**JOINT INSPECTION REPORT OF BISALPUR KISAN SAHKARI CHINI MILLS
LIMITED, BISALPUR, PILIBHIT
(UTTAR PRADESH)**

**Member Secretary, U.P. Pollution Control Board & Ors.
(Appeal No. 23/2020)**

Figure 1 Equalization Tank

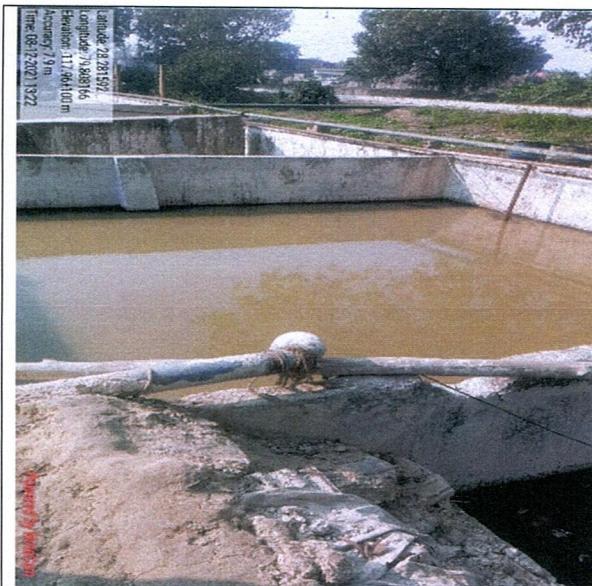
5. During inspection, effluent is received to ETP and only Equalization Tank, Primary Clarifier and Aeration Tank of ETP were in operation. Sample was collected from Equalization Tank and Aeration Tank of ETP. Analysis results are presented below:

Sampling location	Parameters						
	pH	SS (mg/L)	TDS (mg/L)	BOD (mg/L)	COD (mg/L)	MLSS (mg/L)	MLVSS (mg/L)
Equalization Tank	4.29	343	1107	912	1692	-	-
Aeration Tank	-	-	-	-	-	171	148

5. The unit should properly operate its ETP. The unit should ensure operation of all units of ETP system. The unit should maintain proper log book for ETP operation.

Figure 2 Primary Clarifier

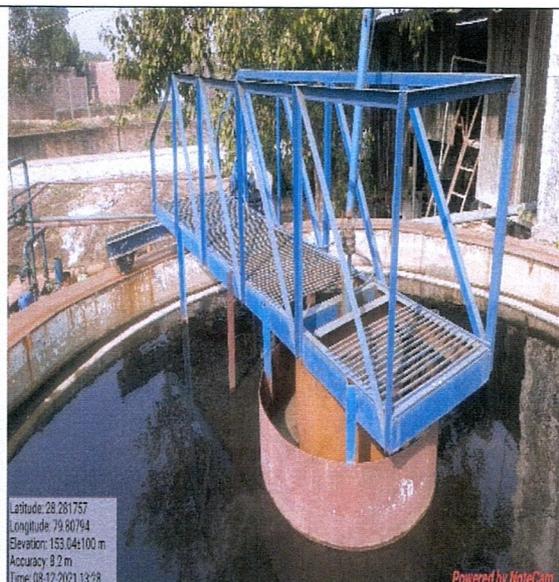
9. Launder of Primary and Secondary Clarifier was not levelled.
10. During inspection, it was observed that effluent drain to ETP is damaged at several place. Due to this, overflow effluent is found stagnant near ETP.

6. The unit should restrict the treated effluent generation as per stipulated norms.
7. The unit should properly level launder of Primary and Secondary Clarifier.

Figure 3 Aeration Tank

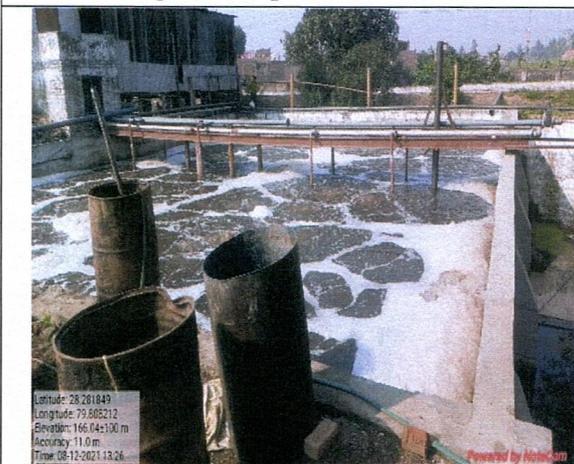
6. It is evident from the results that ETP is not stabilized as MLSS and MLVSS are very low.

7. During inspection, no overflow from Aeration Tank to Secondary Clarifier was observed.
8. The unit has installed OCEMS at the outlet of ETP and it was informed that OCEMS data is connected with UPPCB and CPCB server.

Figure 5 Treated effluent Lagoon

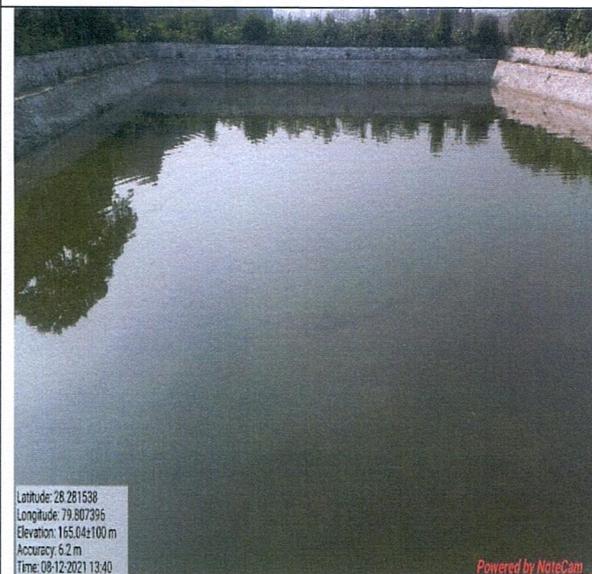
16. The unit has provided a lagoon with capacity -5800 m³ for storage of treated effluent. During inspection, no treated effluent is sent to lagoon. The unit has reported to use of treated effluent in 69.16 Hectare. But, no system for use of treated effluent for irrigation and irrigation area was observed.

12. The unit should provide proper system for conveyance of treated effluent used for irrigation.
13. The unit should repair effluent carrying drain to ETP and ensure no overflow of effluent into land/low lying area.

Figure 6 Sulphur Recovery Plant

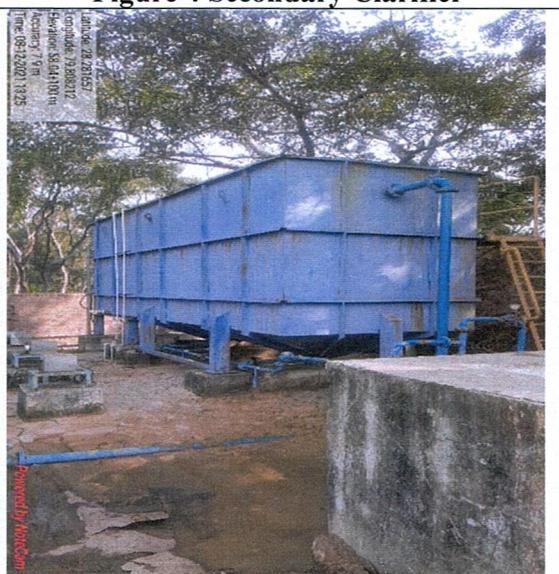
14. The unit has Installed Sulphur Recovery Plant for treatment of spray pond overflow, which was found non-operational. As informed by the unit representative, due to no overflow from spray pond Sulphur Recovery Plant was non-operational. The unit has provided flow meter at Sulphur Recovery Plant.

10. The unit should provide separate energy meter for operation of ETP.
11. The unit should ensure to properly operate Sulphur Recovery Plant and maintain proper log book for operation of the plant.

Figure 8 Bypass drain

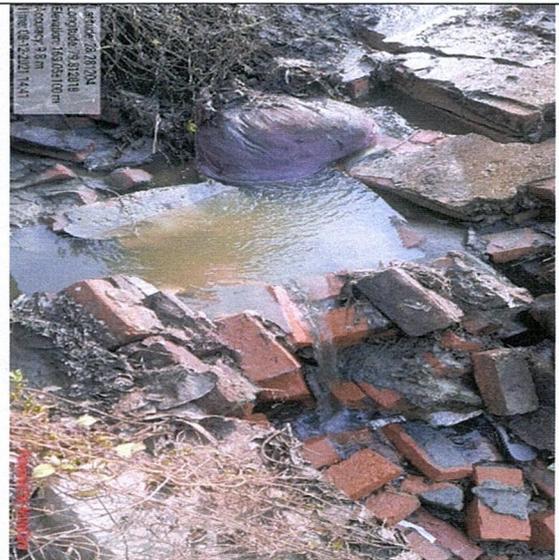
17. During inspection, it was observed that the unit has provided a bypass drain on back side of the unit. Bypass drain is meeting to Garha nalla, which meet to Katna River. Katna River meet River Garra, which ultimately meet River Ganga.

Sampling location	Parameters					
	pH	SS (mg/L)	TDS (mg/L)	BOD (mg/L)	COD (mg/L)	Oil & Grease(mg/L)
Bypass Drain	4.49	64.1	897	480	852	6.85

19. It is evident from above results that unit is discharging untreated and polluted effluent into Garha nalla through bypass drain.

1. The unit should immediately dismantle bypass drain. The unit should ensure that all effluent streams are integrated and routed through ETP.
2. The unit should install electromagnetic flow meter in both the borewells and maintain proper log book of fresh water consumption.

Figure 9 Drain -Near Police Chowki

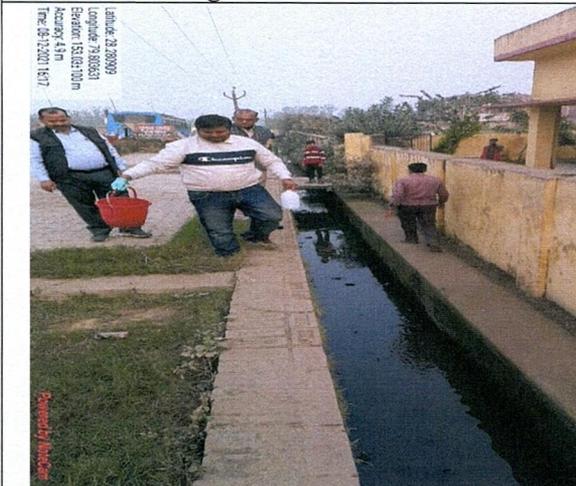
20. During inspection, it was observed that a municipality drain(Garha nalla) was passing adjacent to the unit. Sample of drain was collected before and after the unit. Analysis results are presented below:

Sampling location	Parameters					
	pH	Colour (Hz)	SS (mg/L)	TDS (mg/L)	BOD (mg/L)	COD (mg/L)
Drain sample (before the unit near police chowki)	7.10	125	82.8	1071	84.4	162
Drain sample (after the unit near railway line)	7.06	100	48.8	803	43.6	80.4

Figure 11 Boiler Stack

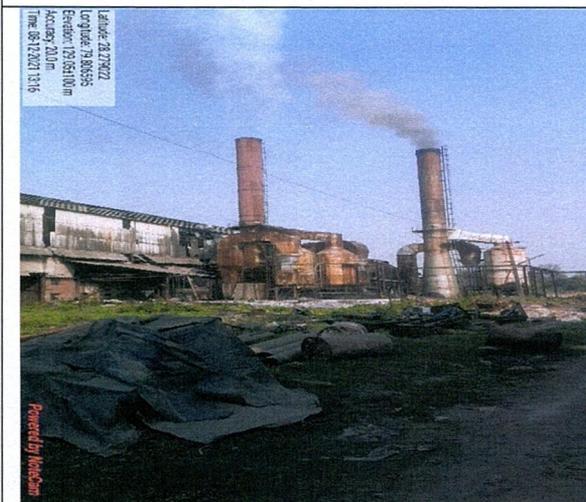
21. The unit has 03 boilers with capacity 2X20 TPH and 1X30 TPH using bagasse as fuel. Emissions from Boiler with capacity 20 TPH is emitted through common stack of

height 30 m. Similarly, emission from boiler with 30 TPH is emitted through stack of height 30 m. Monitoring platform in both stacks was not as per CPCB guidelines.

8. The unit should provide proper stack monitoring facilities as per CPCB guidelines.
9. The unit should provide filtrate system in Sludge Drying Beds and ensure that filtrate should be treated in ETP.
